City of Portland, Maine - Building or Use Permit Application

Location of Construction: 51 SEWALL ST	Owner Name: RHEUMATOLOGY REALTY ASS	Owner Address: 51 SEWALL ST	Phone:
Business Name:	Contractor Name: Maine State Builders	Contractor Address: 245 Warren Ave Portland	Phone: 2077735504
Lessee/Buyer's Name	Phone:	Permit Type: Additions - Commercial	Zone: R-1

Past Use: Commercial/	Proposed Use: Commercial/ addition and renovation to existing office space	Permit Fee: \$4,520.00	Cost of Work: \$450,000.00	CEO District: 3
Proposed Project Description: addition and renovation to existing office space		FIRE DEPT: <input checked="" type="checkbox"/> Approved <input type="checkbox"/> Denied	INSPECTION: Use Group: B Type: SB 9/14/06

RE: Rheumatology Associates Addition to 51 Sewall Street

SECOND FLOOR PLAN

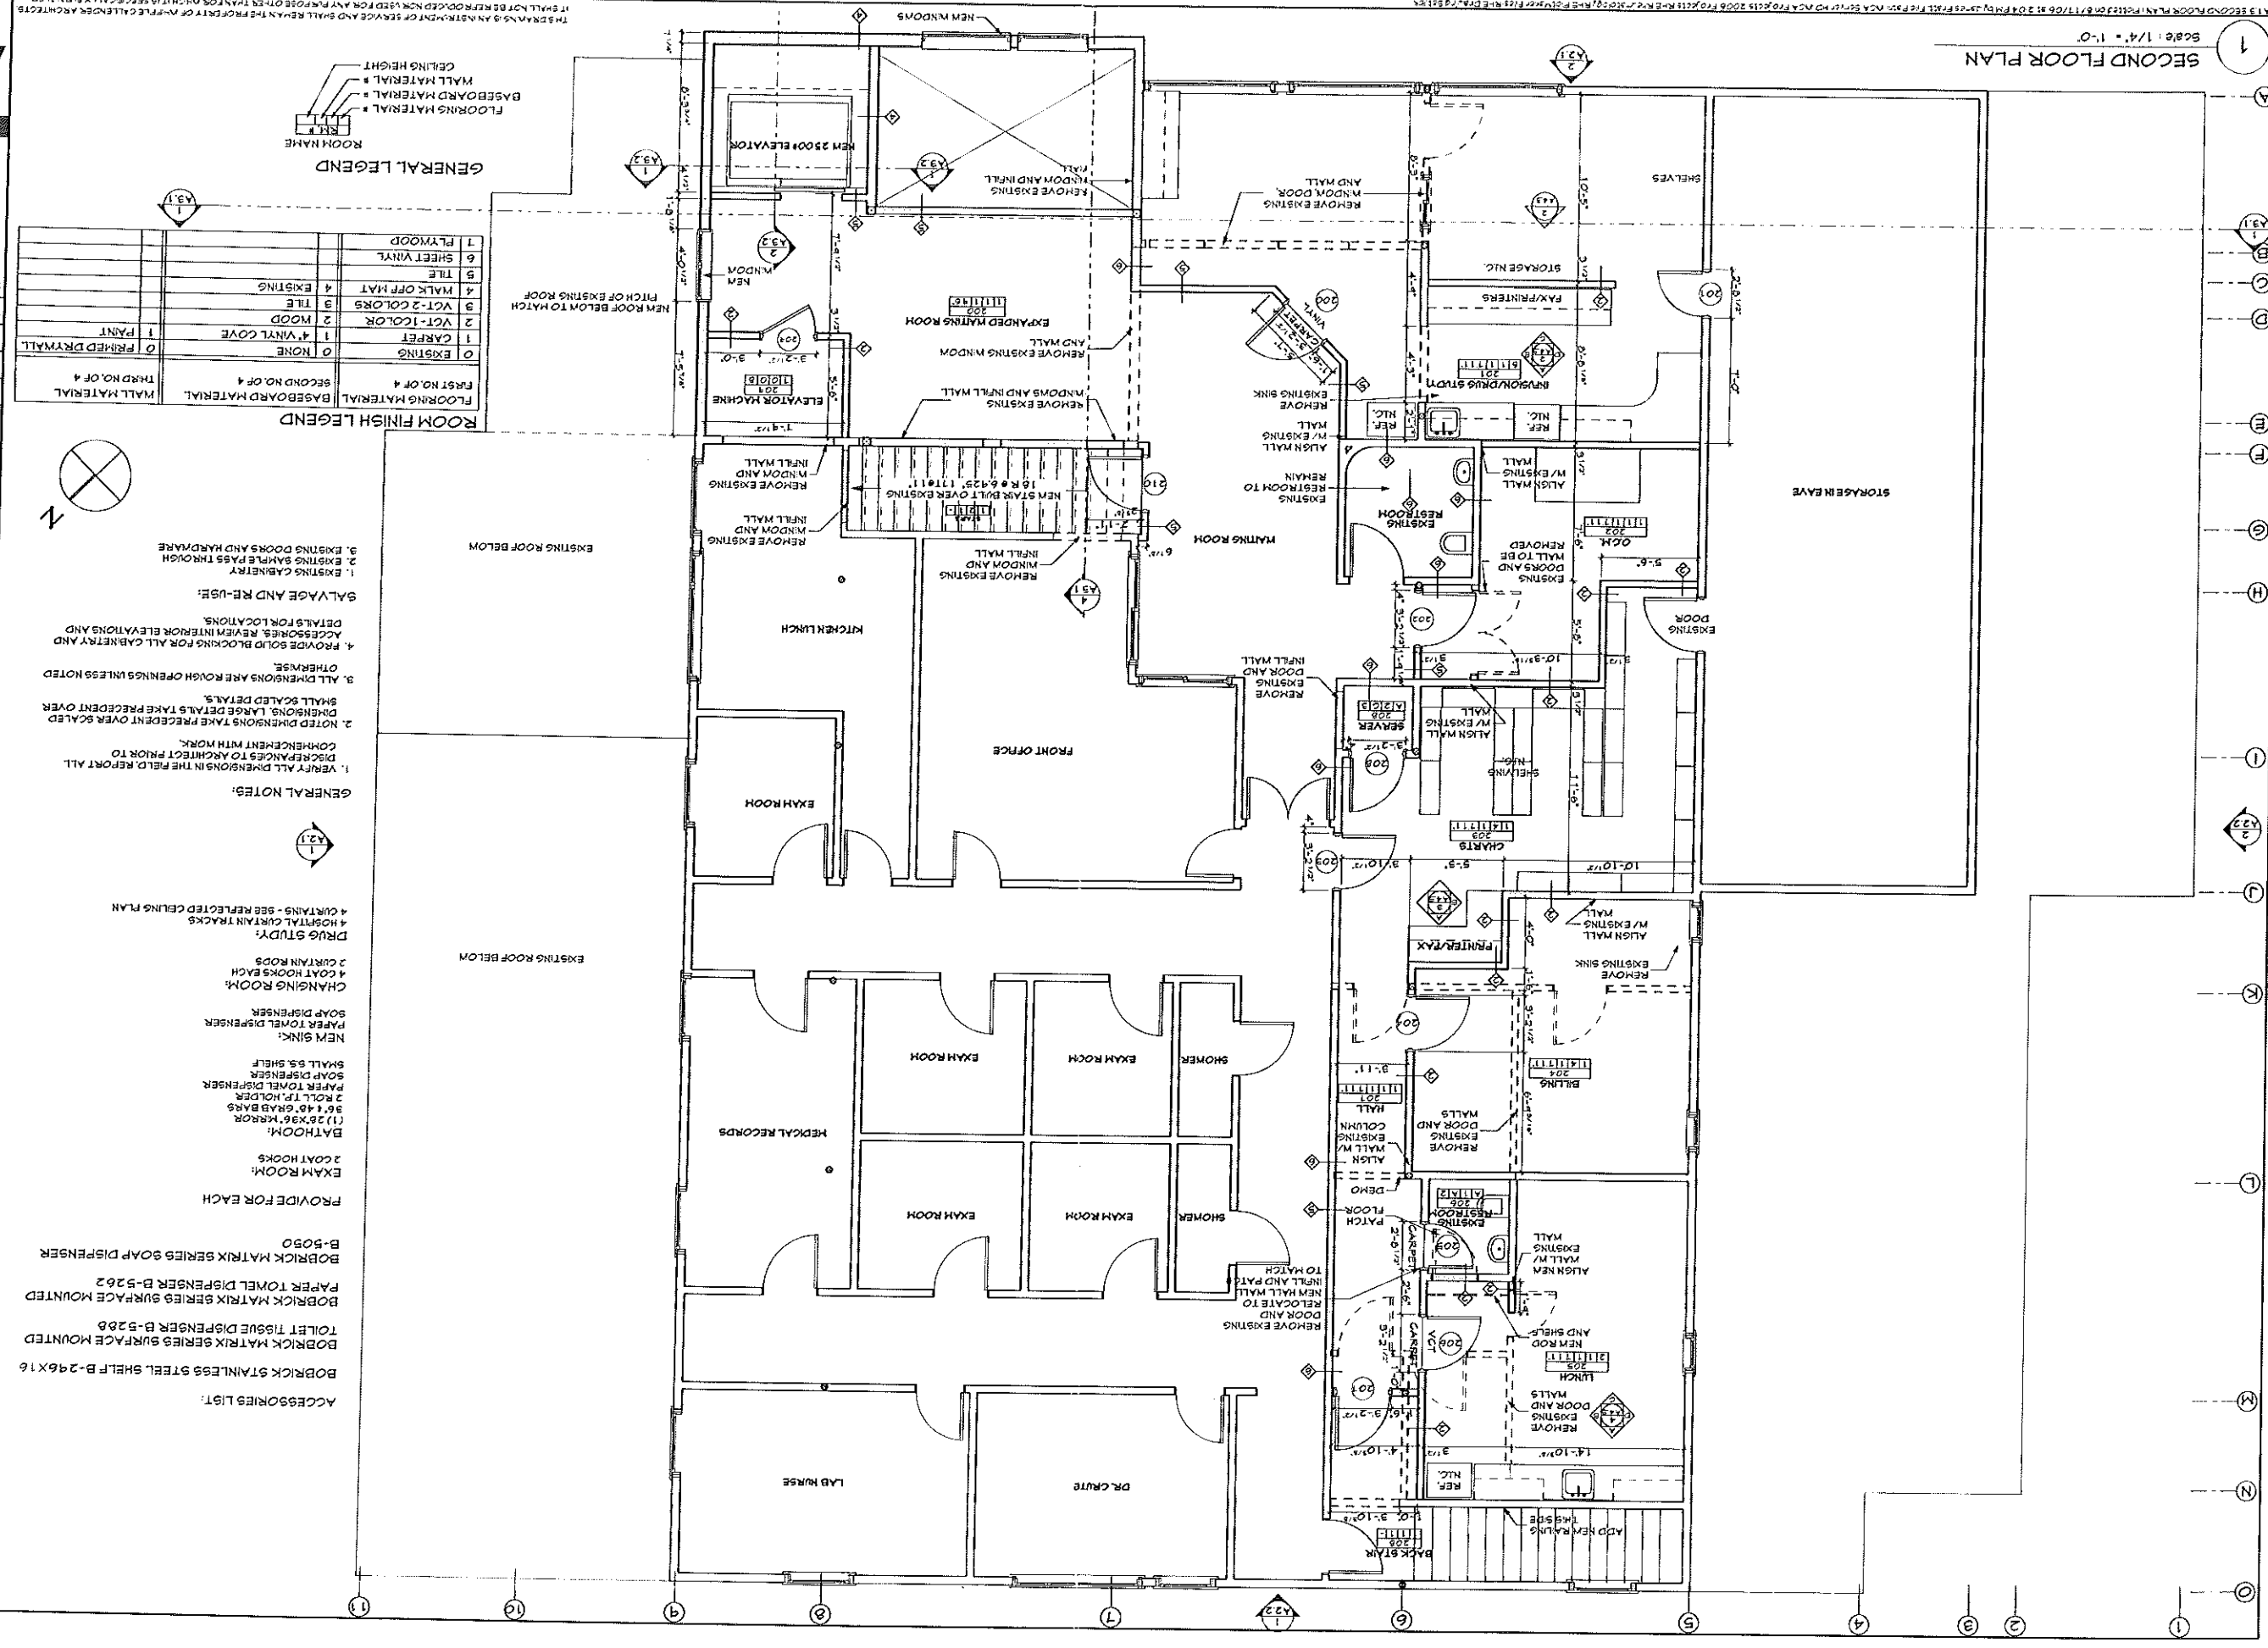
Comments:
 9/1/2006-mes: site plan #2006-0163 not signed off yet - WAIT FOR STAMPED APPROVED SITE PLAN BEFORE ISSUING BUILDING PERMIT
 9/2/2006-mjn: Plans are not stamped by the architect., Left Voicemail with Ann Calendar
 Need Stair Cross Section.
 Need to discuss Corridor ratings,(non sprinklered building, "B" use group with an occupant load of greater than 30) 1-hour required, windows are shown on the floor.(table 1016.1)
 Also Need to discuss the existing potectial dead end corridors on the second floor that exceed 20 feet.(Section 1016.3 IBC)
